LIGO PROJECT
 designed by **R. De Salvo**
 drawn by **G. Gemmaro-PROMECC**
 date **28-12-04** scale **1/3**
HAM-OPTICAL BENCH
 LIGO-D051118-00-D
 sheet 117 of A 1
 DETAILS TABLE

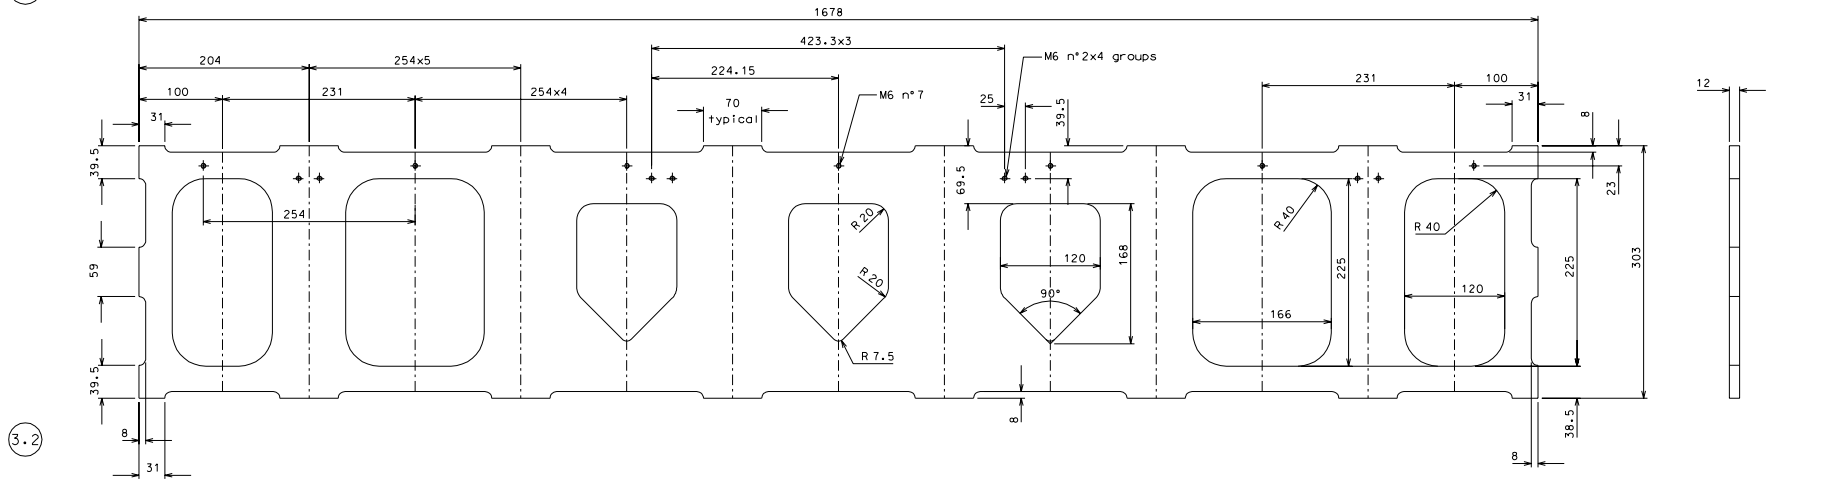
ref.	description	date	signature
	added holes for cables	5-10-05	
	modifications
